## Summary of issues raised by the public and Council response

## 2 Consideration of issues raised

**Figure 1:** Figure showing the site's existing easements (the site is shown in purple).

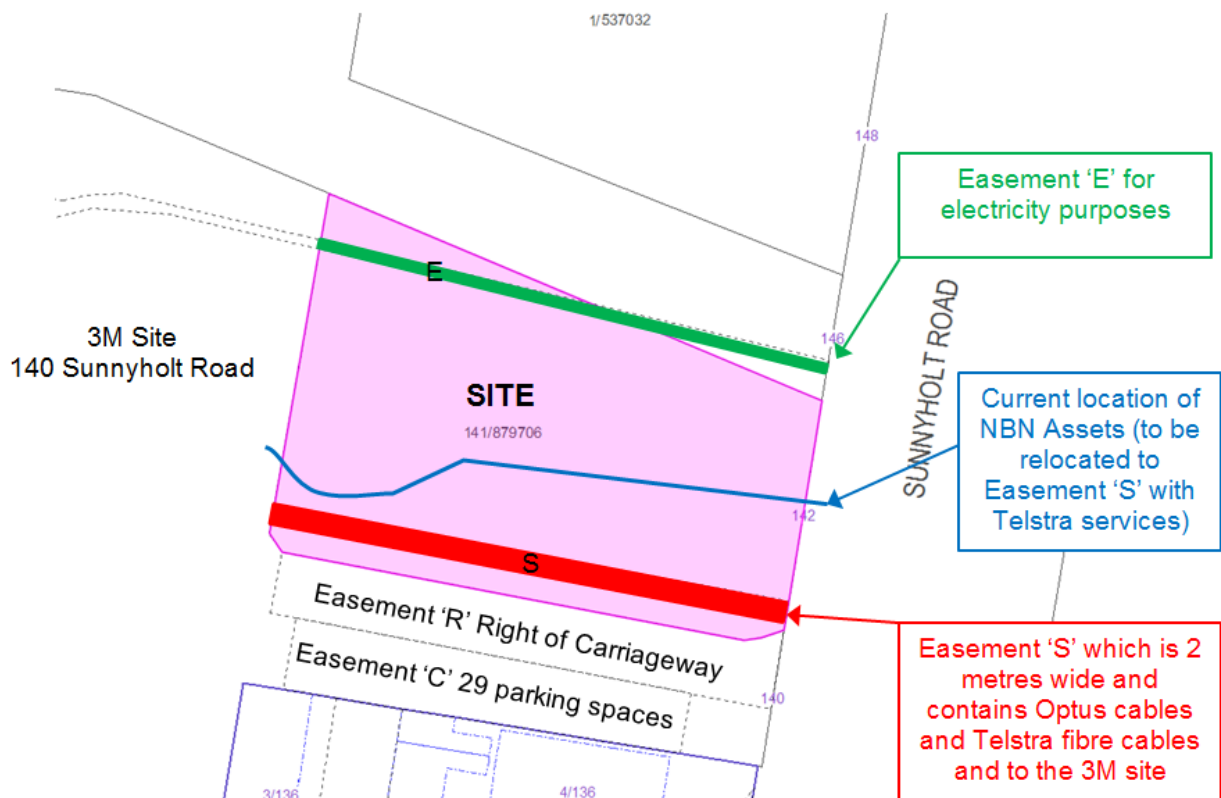
The objections raised in the submission included:

- Concern about their driveway and parking areas being obstructed and increased congestion during the construction and operation of the proposal.
- Safety concerns for vehicles and pedestrians using the driveway and parking area.

- Concerns that the driveway is not capable of accommodating the increased intensity of use of the site as a result of this proposal.
- Concern that the purpose of the easement is not to allow for access through the 3M site of the magnitude proposed. The use of an easement cannot be extended beyond the scope of the use at the time of when it was originally granted.

- The carpark and driveway were intended to be used for the owner of the development site to access its land, and now it is anticipated that virtually any person in connection with the hotel could use the carpark and driveway, impeding 3M's ability to use and enjoy its own land free from disturbance or interference.

- The DA states that 128 car parking spaces are to be created as a part of construction. The use of the carpark on 3M's land then seems to be redundant, if this were to be the case. At the time of the creation of this easement, it was never expected that the carpark would be used as an 'ancillary' carpark to an adjoining hotel which would contain ample parking for its patrons and guests.

In response to these objections, the Applicant met with the 3M and amended the proposal, which is the subject of this application. The Applicant and submitter also prepared and signed a Deed of Agreement to reflect an agreement between the parties. The submission was then formally withdrawn by 3M.

3M has confirmed that the amended proposal and Deed of Agreement resolves its concerns and their submission was formally withdrawn.
